Amendments to standard IEC / EN 61010-031 : 2016-07

Overview of product modifications

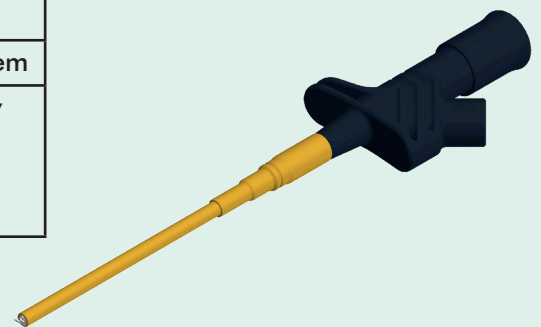
article description	KLEPS 1600 black/red
article number	975106100/-101
product group / system	clamp-type test probes, 2mm safety system
changing	reclassification of measurement category from CAT III to CAT II (product marking was adjusted accordingly)

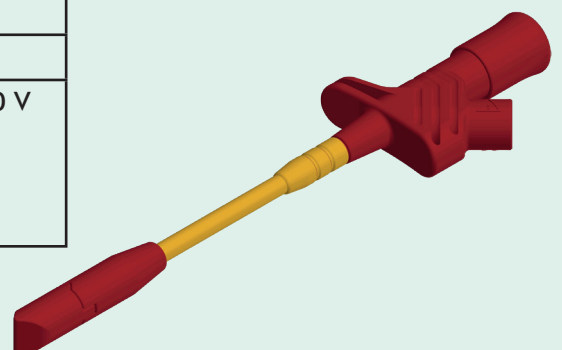
article description	KLEPS 2600 black/red
article number	972306100/-101
product group / system	clamp-type test probes, 4mm safety system
changing	reclassification of measurement category from CAT III to CAT II (product marking was adjusted accordingly)

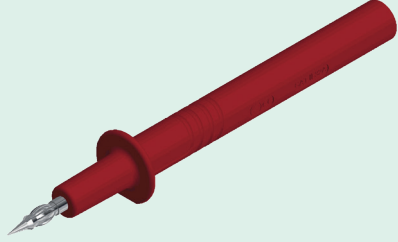
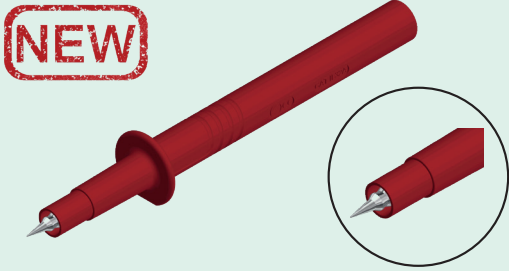
article description	KLEPS 2700 black/red
article number	972307100/-101
product group	clamp-type test probes
changing	Adjustment of rating data AC/DC 1000 V to 30 VAC / 60 VDC So far: 4 mm safety system New: 4 mm standard system

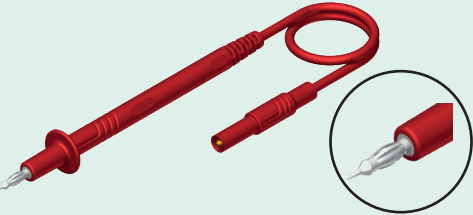
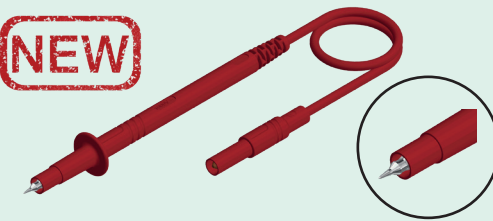
article description	PRUEF 2700 black/red	
article number	972319100/-101	
Produktgruppe / System	test probes, 4 mm safety system	
changing	constructional modification Improvement of contact protection, CAT II still valid	
picture	so far	from 03.07.2018
